WILLIAMSON COUNTY, TEXAS

CHANGE ORDER NUMBER: 5

Project Name: Ronald Reagan Boulevard Widening

1A. Design Error or Omission. Incorrect PS&E.: This Change Order adds an item for the transition sections of the metal beam guard fence (MBGF) to the concrete rail at all of the bridge locations.

Designed: ANK	FED. RD. DIV. NO. X	STATE TEXAS	PROJECT NO.		HIGHWAY NO.	
Checked: ANK						
Drawn: ANK	DIST.	COUNTY	CONTROL NO.	SECTION NO.	JOB NO.	SHEET NO.
Checked: ANK		WILLIAMSON				21

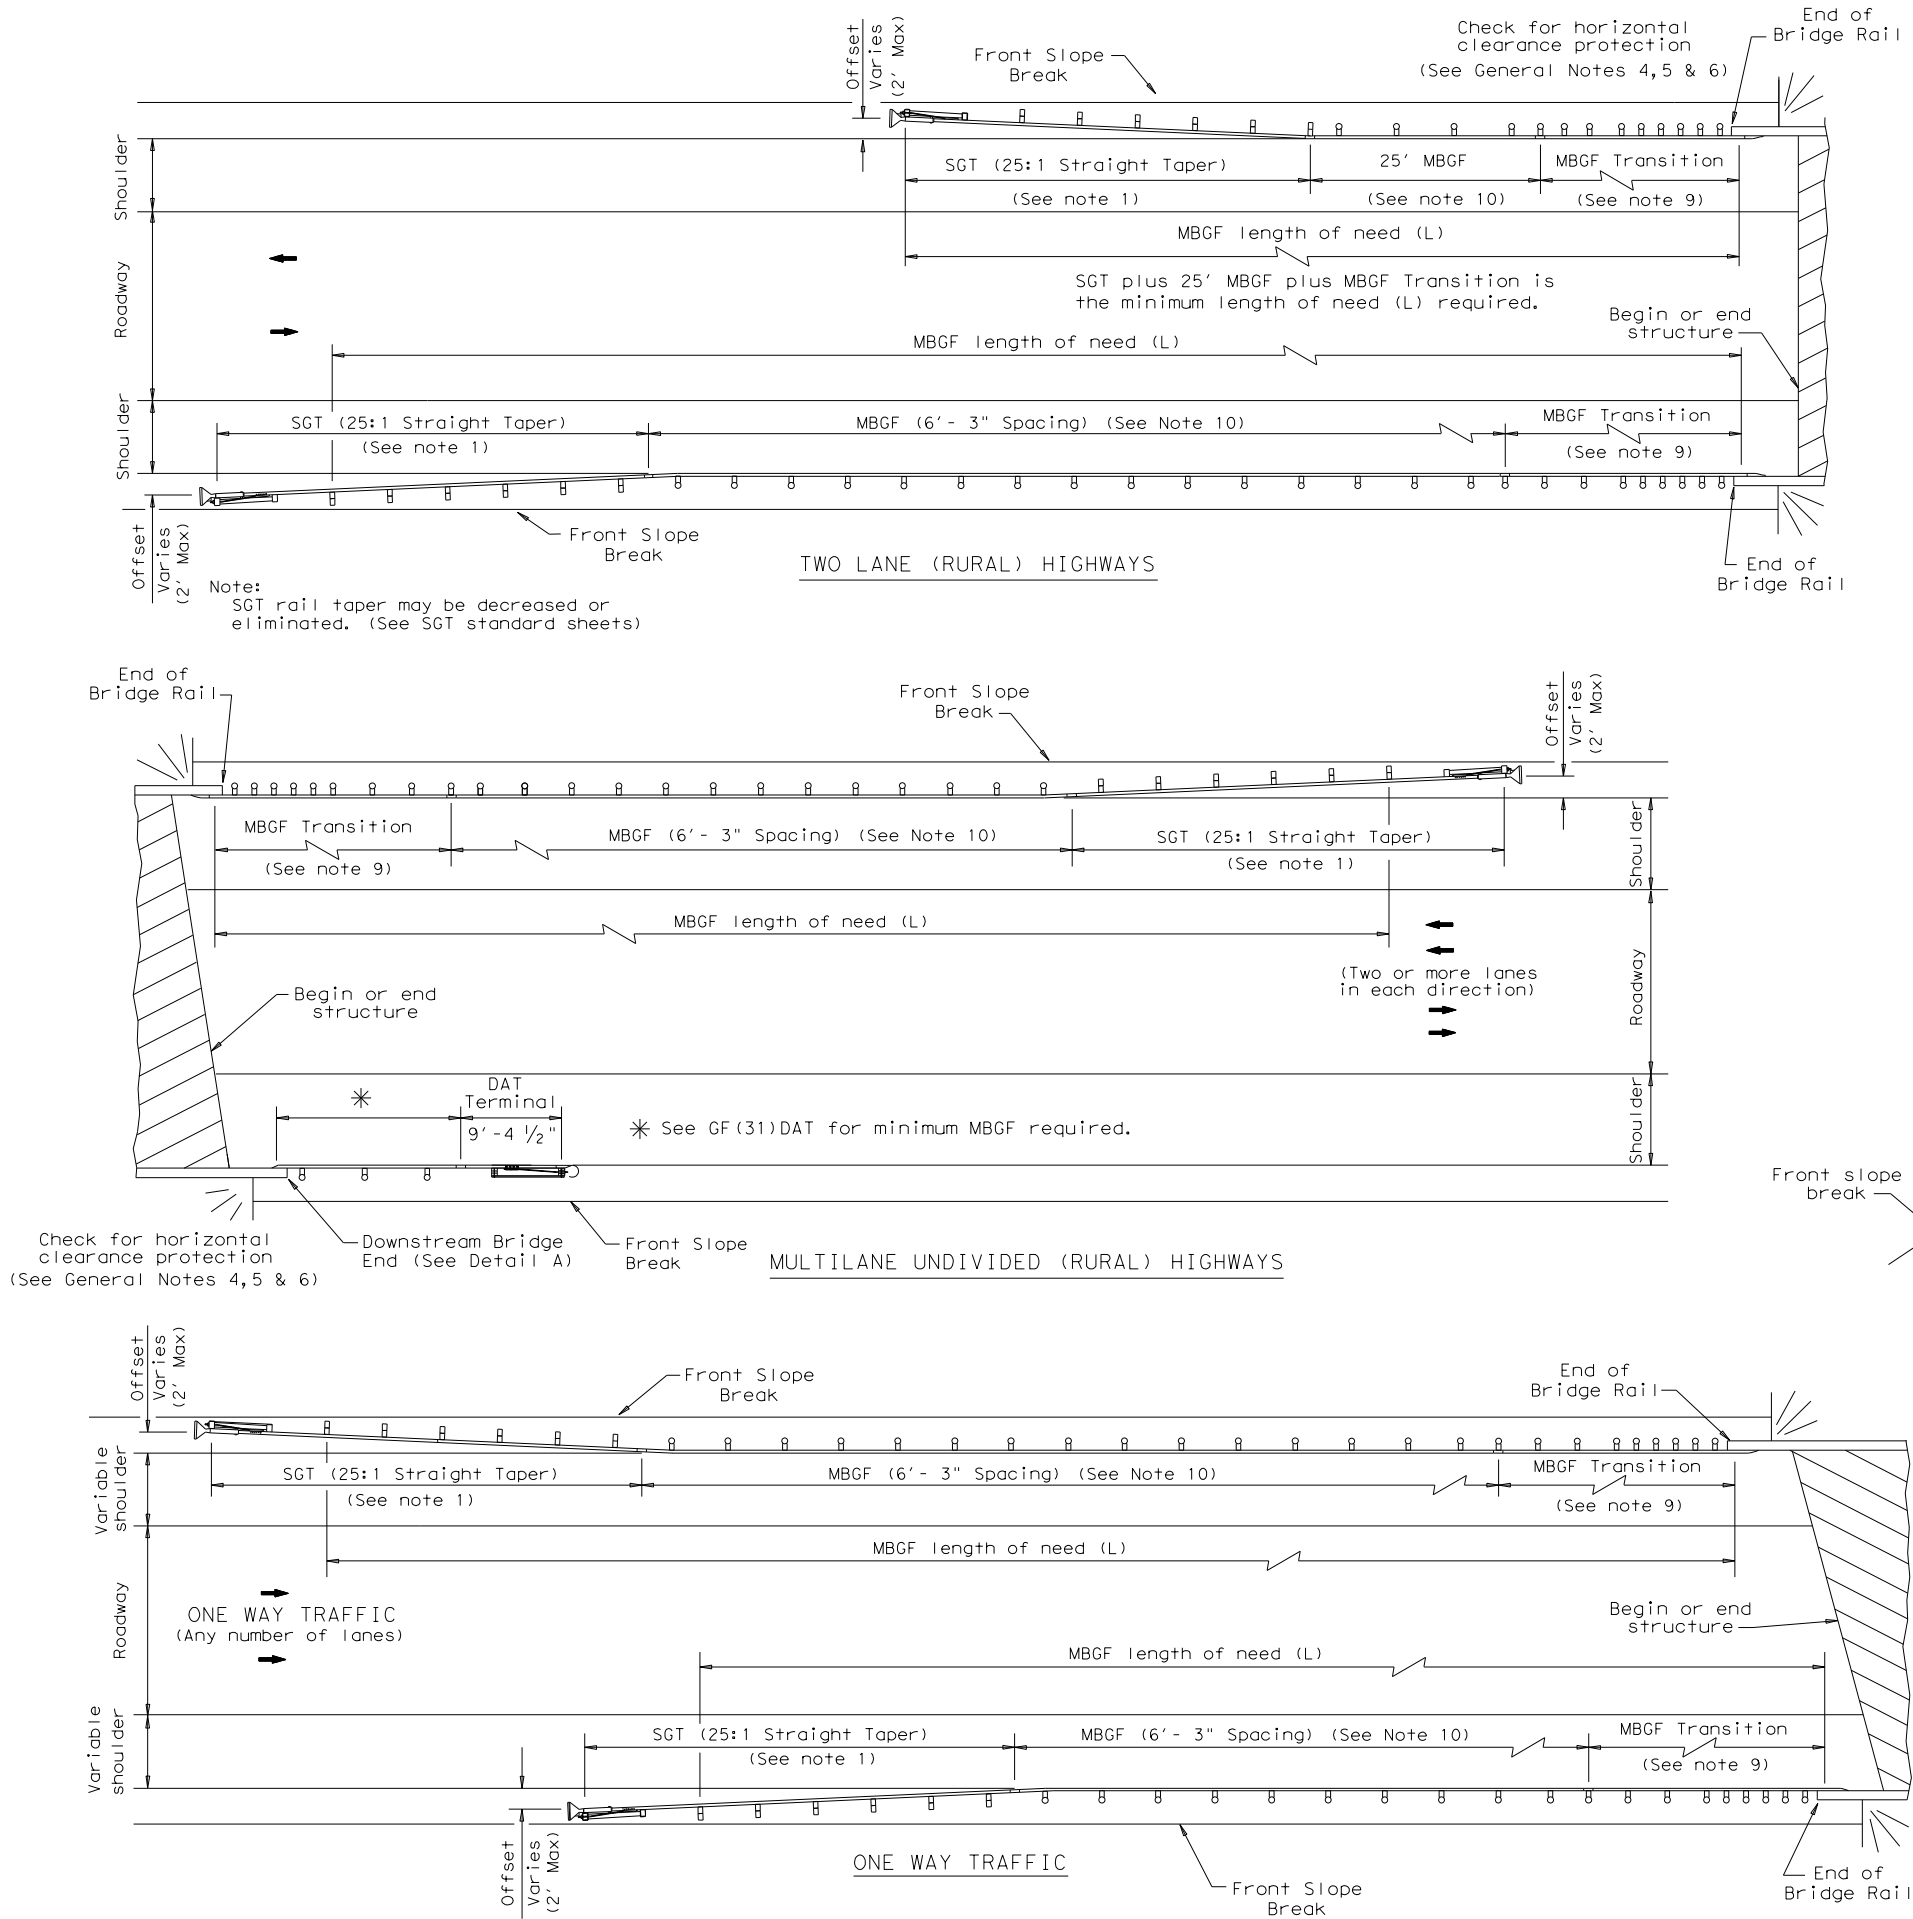
RFI 44 - MBGF TRANS	ANK	1/31/25
	CULVERT ADJUSTED FOR GRADING	CAS	1/22/25
	RFI 33 - RIPRAP UPDATES	ANK	12/20/24
	RFI 22 - BRIDGE DRAIN RIPRAP	BAM	11/14/24
NO.	REVISION		BY DATE

C-221 rail begins at Sta 2636+12. "Begin bridge rail" label and dimension in the bridge layout (Sheet 424) has been updated. The original quantities and rail length have not changed. Connected to the bridge rail on both downstream sides is a MBGF Trans (Non-Sym), the details for which are shown on the BED-14 standard included in this package (sheet 214A). Item 540 6018 MBGF Trans (Non-Sym) has been included to match the plans. This has been updated in Sheet 21.

BED-14

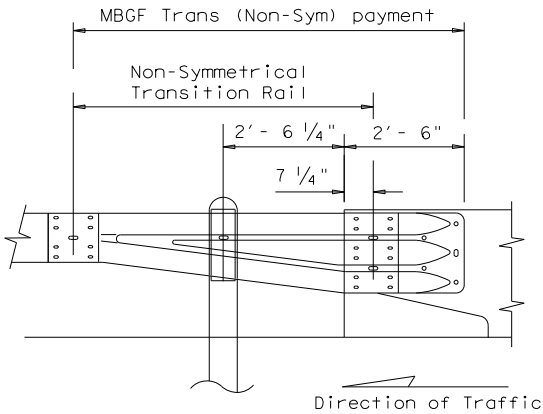
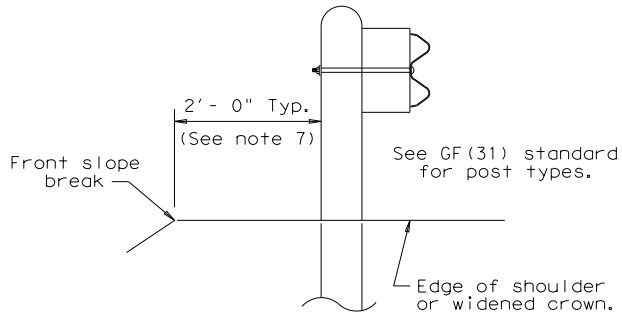
New or revised plan sheet(s) are attached and numbered: 2, 21, 214A, 424
